Docket Nos. 50-315  
and 50-316  
April 27, 1984

The Commission has issued the enclosed Amendment No. 80 to Facility Operating License No. DPR-58 and Amendment No. 63 to Facility Operating License No. DPR-74 for the Donald C. Cook Nuclear Plant, Unit Nos. 1 and 2, respectively. The amendments consist of changes to the Technical Specifications and license conditions in response to your letter dated December 15, 1983, and are being made to simplify or clarify the licenses for the convenience of the NRC.

Amendment No. 80  
License No. DPR-58

Amendment No.63  
License No. DPR-74

Figure 6.2-2 Facility Organization - Donald C. Cook - Unit No. 1

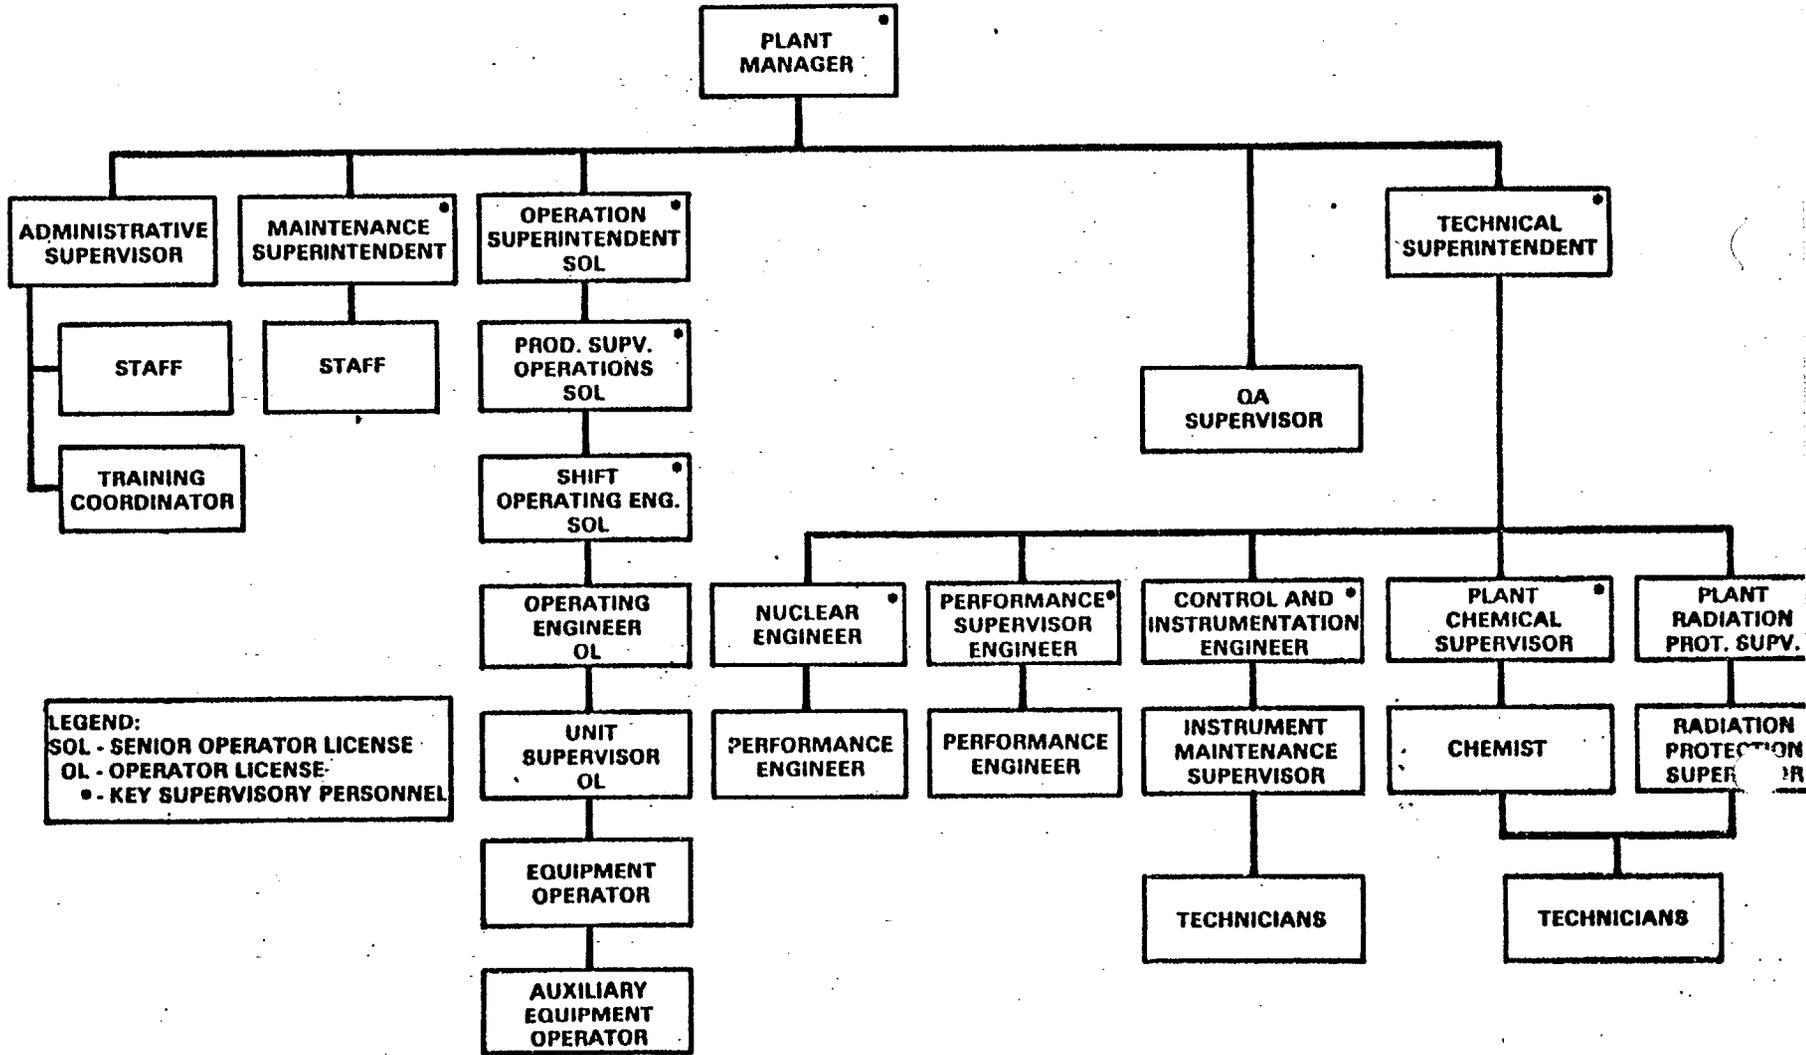
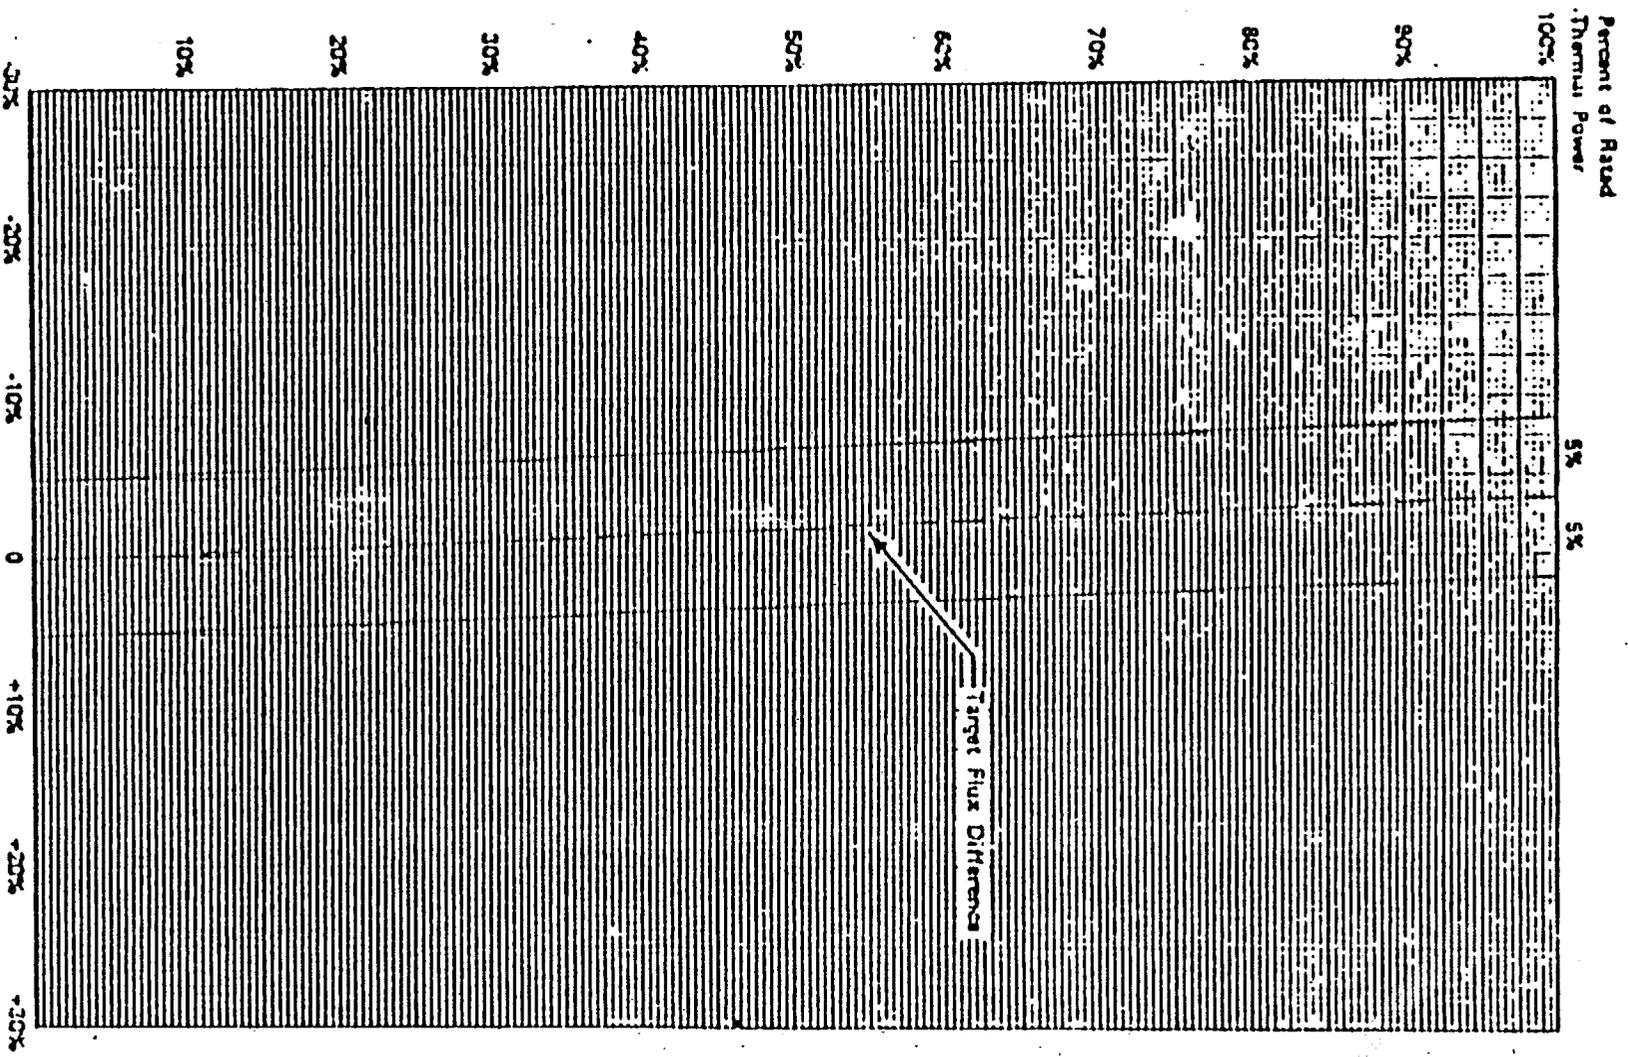
6. Technical Specification page 6-3 is corrected to include lines in the margin to indicate the changes approved by Amendment 63.
7. Technical Specification page 3/4 9-10 is changed to correctly distinguish between radiation "channels" and radiation "monitors." Amendment 60 dated September 9, 1982, incorrectly referred to channels in the surveillance requirements. The correct term is monitors. This correction which was discussed in the Federal Register Notice (49 FR 3344) issued January 26, 1984, has been brought to the attention of the licensee and is made by the NRC to clarify the license.

Figure 6.2-2 Facility Organization - Donald C. Cook - Unit No. 2

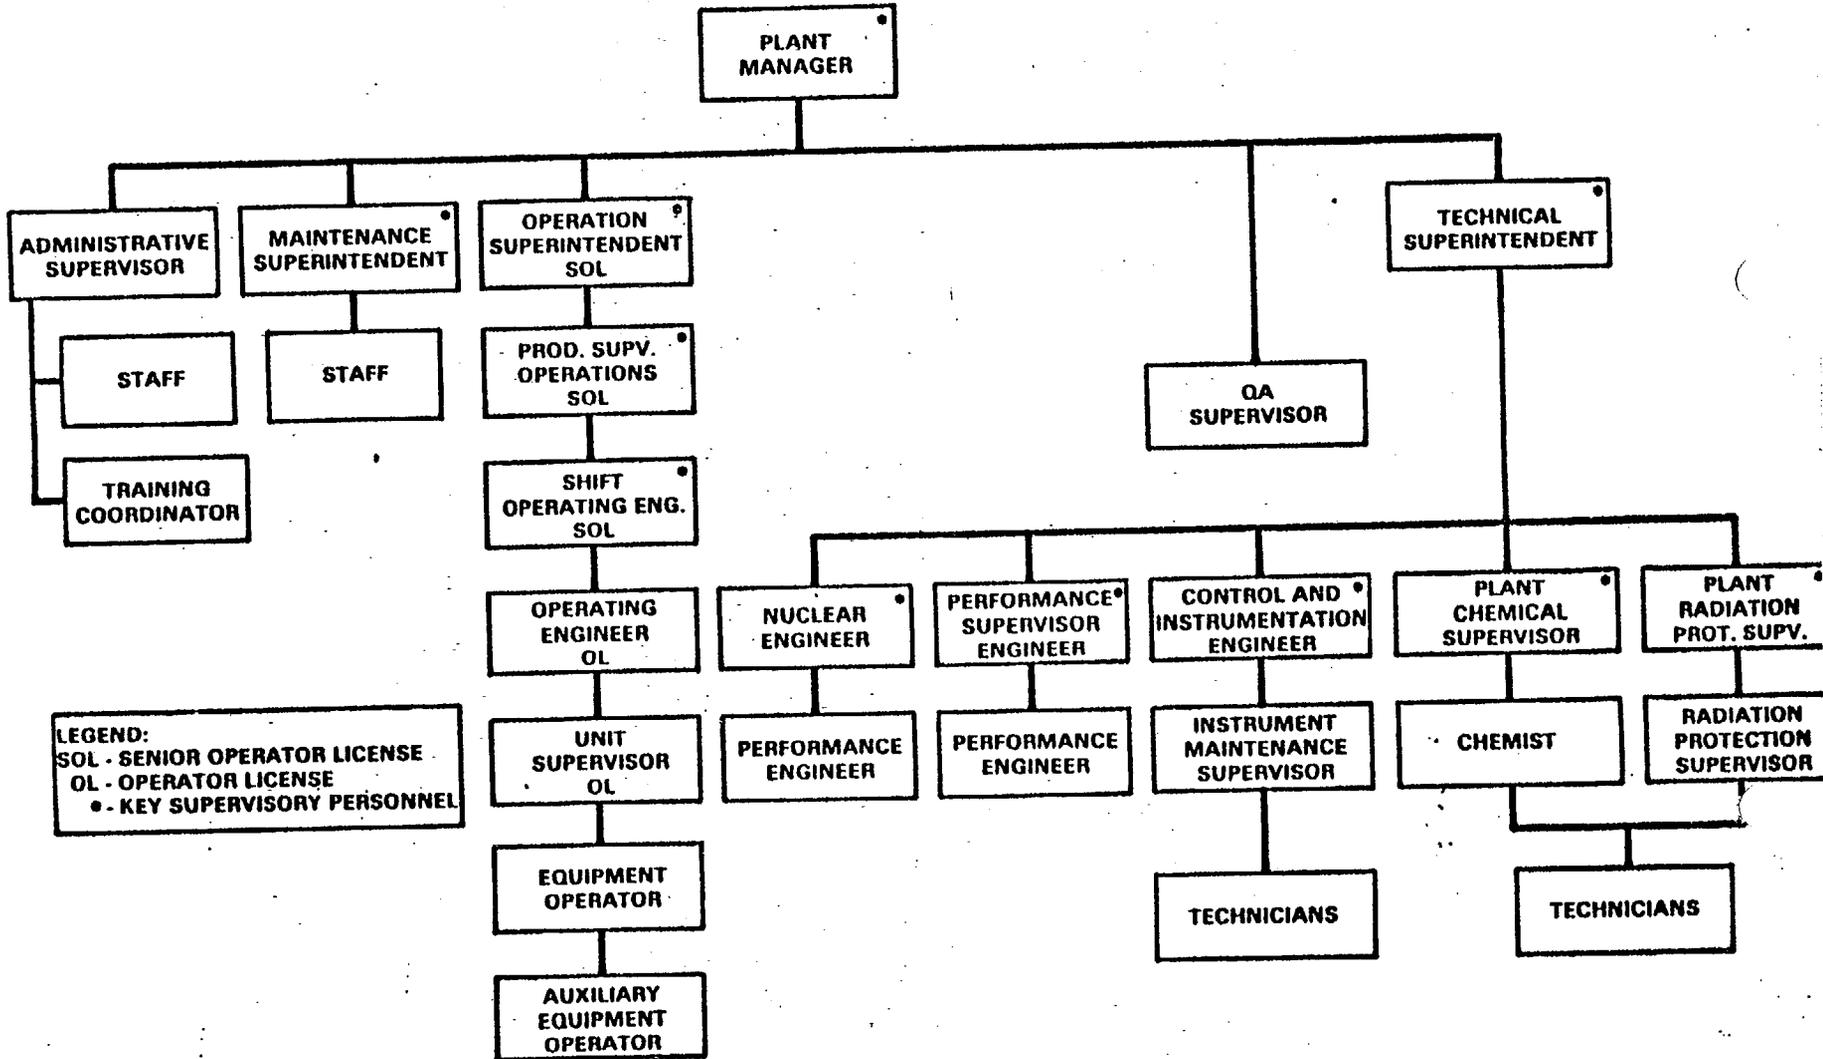
9. Technical Specification page 6-3 is changed by adding lines in the margin to indicate changes approved by Amendment 45.
10. In Amendment 45 issued October 4, 1982, the index page to Technical Specification changes indicated a number of pages were included for convenience. These pages were the reverse side of pages that were changed. Since these "convenience" pages did not change, the "Amendment 45" revision reference on each of those pages is removed.
